Well Name: RIO BLANCO 33	Well Location: T22S / R34E / SEC 33 / NESW / 32.3463691 / -103.4776653	County or Parish/State: LEA / NM
Well Number: 03	Type of Well: OIL WELL	Allottee or Tribe Name:
Lease Number: NMNM100864	Unit or CA Name:	Unit or CA Number:
US Well Number: 3002537860	Operator: DEVON ENERGY PRODUCTION COMPANY LP

Notice of Intent

Type of Submission: Notice of Intent	Type of Action: Plug and Abandonment
Date Sundry Submitted: 02/17/2025	Time Sundry Submitted: 01:32
Date proposed operation will begin: 04/15/2025

## WELLBORE DIAGRAM - CURRENT

WELLBORE DIAGRAM - PROPOSED

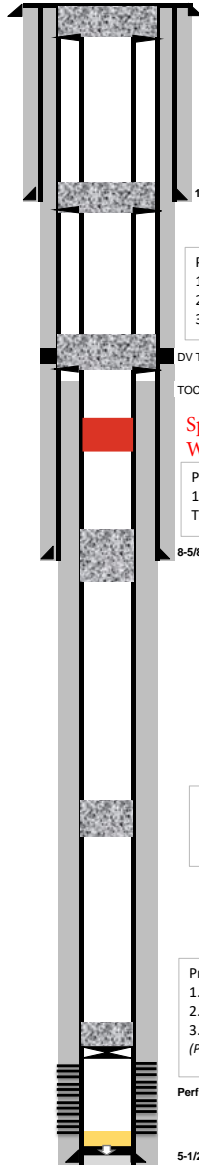
**REVISED**

Spot cement from 4140' to 3674'.  
WOC and Tag. 120 sxs Class C.
